Letter of response

Proposal: Application under Town and Country Planning Act 1990 (as amended) for Approval of Details Reserved by a Condition in relation to permission LPA ref. 200188 / Appeal ref. APP/E0345/W/21/3276463 (granted on 17/03/2022) varied under Section 73 of the Town and Country Planning Act 1990 (as amended) application number 231673 (granted on 27/03/2024) - to discharge condition 28.

At: 55 Vastern Road, Reading, RG1 8BU

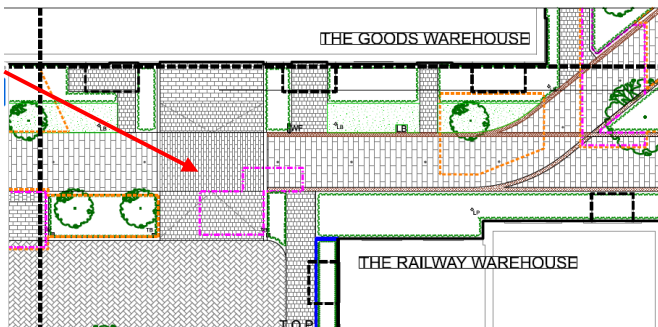
"As an aside, I do note significant areas of PV panels shown on the approved roof plans (under 231673) and wonder why these areas have not been combined with green roofs as the two are mutually inclusive."

As you are aware, we have (as a department) sought specific CPD from green roof experts in order to be able to respond to regularly cited concerns about green roofs. With regard to the fire risk, a properly maintained green roof (as one would expect) would not have dry vegetation. Green roof vegetation need not be tall hence shading should not be an issue.

It is commonplace for roofs to include both PVs and some form of green roof – the two are mutually inclusive. This combination is widely accepted within the profession and by developers and it is expected that inclusion is considered. Further advice and to reassure the applicant on its suitability, advice can be obtained from GRO in their Biosolar guidance and also Fire Guidance

Further input is therefore still required on the green roof provision (alongside PV panels)."

During this approval process, Condition 26 was agreed requiring details of photovoltaics to secure measures to adapt to climate change, in the interests of visual amenity and to protect local context and character. As set out on the approved drawings, there was never any intention or requirement to install green roofs alongside photovoltaic panels.

Furthermore, as you are aware, we have provided a structural statement from the structural engineers and ensured that the green roofs (where proposed) have been accounted for and can be delivered. Again, revisiting a planning strategy to introduce additional green roofs that have never been part of any planning proposals, structural calculations, costs and designs is not achievable at this stage of the project without significant structural upgrades and shouldn't be enforced as a standard practice.

In addition to the above, we have also explained that the buildings are high-rise and subject to Gateway approval. Gateway Stage 1 has already been approved and is in line with the planning approved drawings granted under Appeal ref. APP/E0345/W/21/3276463. Gateway Stage 2 is imminent and is also following planning approved drawings, secured under the above approval. Any changes at this stage would be deemed as a major change to the project and would not be viable at this stage.

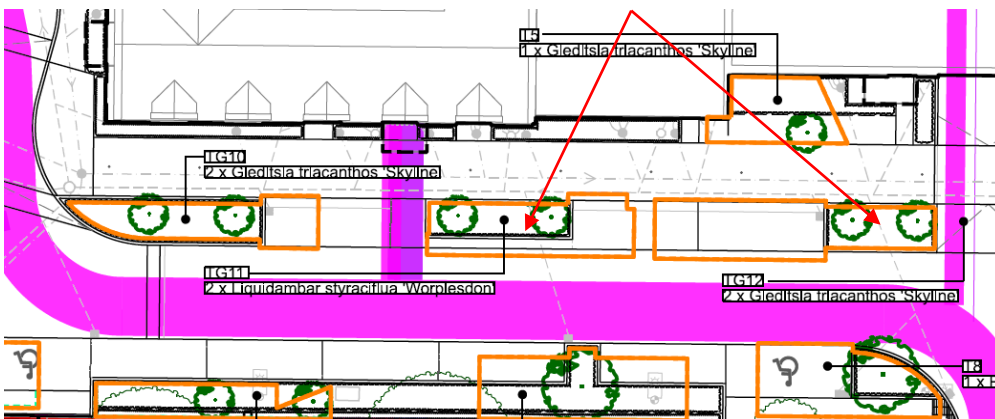
"It appears to resolve this issue a section of root crate has been removed, as shown on Landscape GA Segment 6 0448-FIR10-XX-XX-DR-L-810-1006 P07 leaving a root crate area separate (the other side of the service corridor) to the tree pits – I'm not clear how the trees will then utilise this separated crate area, which is, in any case, crossed by approved drainage runs (see extract further below)."

"However, there does seem to be a conflict with the drainage route, going through two areas surrounded by root barrier and through root crates, as indicated below:"

It appears to be a drawing mistake showing the additional crate. Please see amended drawing 0448-FIR10-XX-XX-DR-L-810-1006 P08 without the lines.

These are gully connections. In this instance, the gully runs identified will be deep enough that they will pass beneath the crated storage and not impact rooting volumes.
